ALERT SERVICE BULLETIN

NO. 212-09-133

MODEL AFFECTED: 212

SUBJECT: 205-030-856-157/-159 ELEVATORS, ONE TIME INSPECTION OF.

Figure 1
Angle Measurements

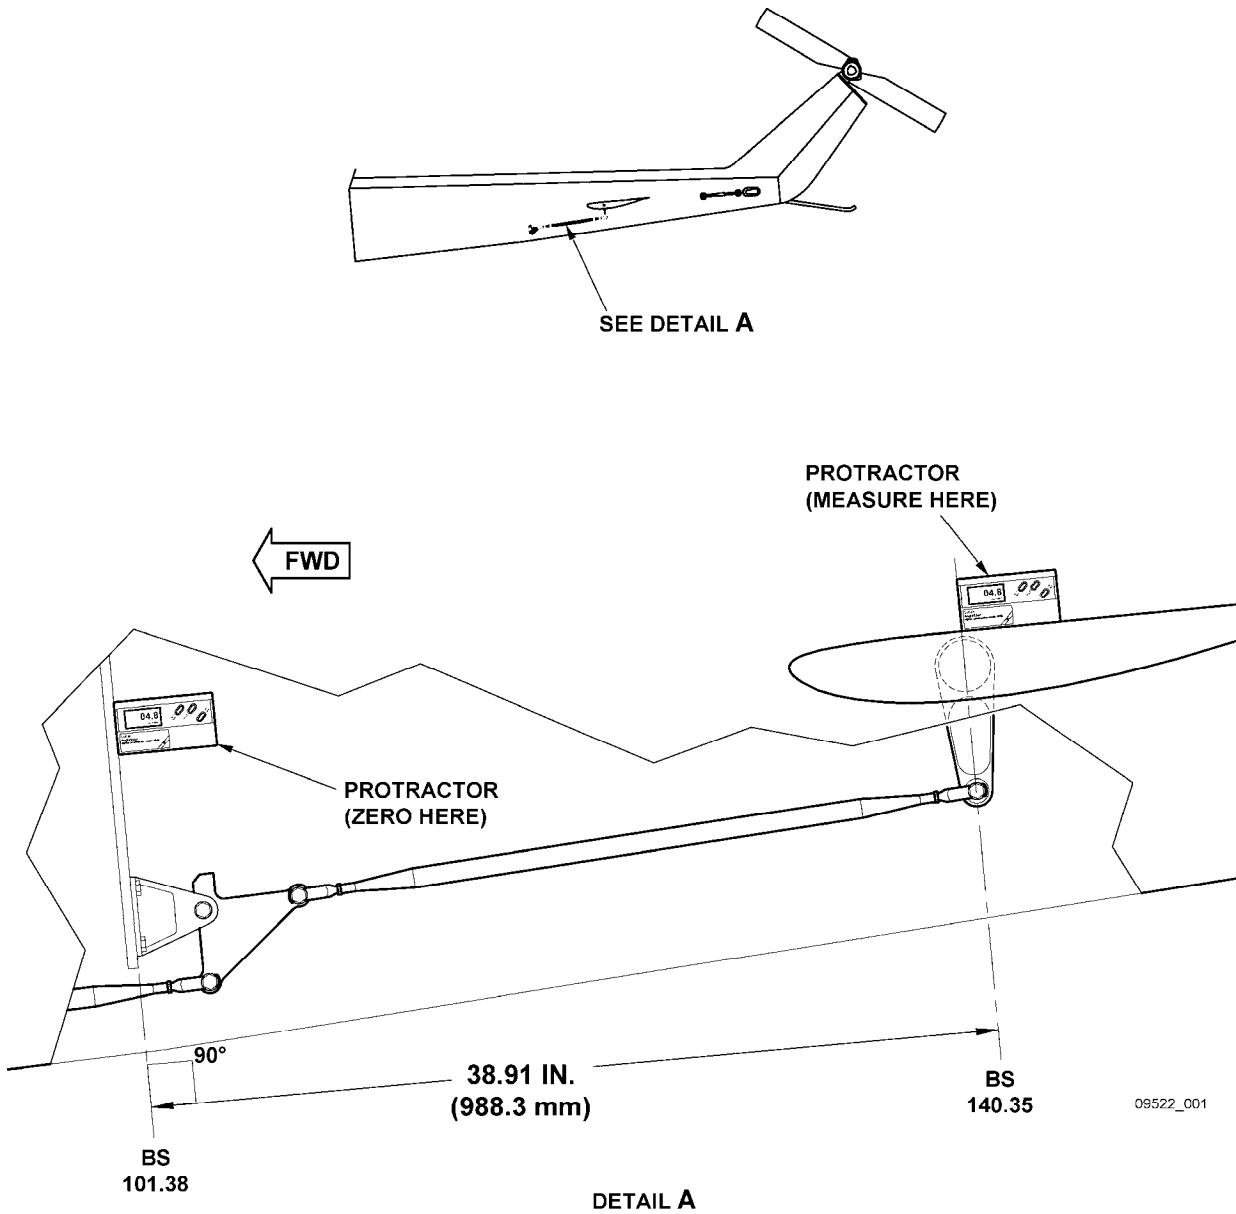
1. Prepare helicopter for maintenance.
2. Confirm any of the elevators are within serial number range by referring to their bonded and riveted dataplate near the trailing edge.
3. Remove tailboom belly access panel just aft of Boom Station (BS) 101.38.
4. Using a measuring tape, position center of elevator horn control bolt at 38.91 +/- 0.03 inches (989.8 +/- 0.8 mm) from (and perpendicular to) the aft face of bulkhead at BS 101.38. Refer to Figure 1. Move cyclic controls as required and apply cyclic control friction when done.
5. Place digital protractor on aft face of bulkhead at BS 101.38. Zero protractor.
6. Move protractor to top skin of RH elevator second rib, edge of protractor should be aligned with the 8th rivet from the leading edge of the elevator. Record relative angle as Angle "A". Zero protractor.

7. Move protractor to top skin of L/H Elevator and record the angle as Angle "B".

8. The correct value for Angle A is 0.00 +/- 0.50 degree. The correct value for Angle B is 3.00 +/- 0.75 degree.
 - a. If Angle "A" and Angle "B" are not within their applicable tolerance, replace the RH elevator as per Maintenance Manual within the next 100 flight-hours and proceed to Part II thereafter.

- b. If Angle "A" is not within its applicable tolerance but Angle "B" is within its applicable tolerance, replace the RH elevator as per Maintenance Manual within the next 600 flight-hours and proceed to Part II thereafter.

- c. If Angle "A" is within its applicable tolerance but Angle "B" is not within its applicable tolerance, replace LH elevator as per Maintenance Manual within the next 100 flight-hours. No further action is required. Go to Part II, step 6.

- d. If Angle "A" and Angle "B" are both within their applicable tolerance, both elevators are compliant and no further action is required. Go to Part II, step 6.
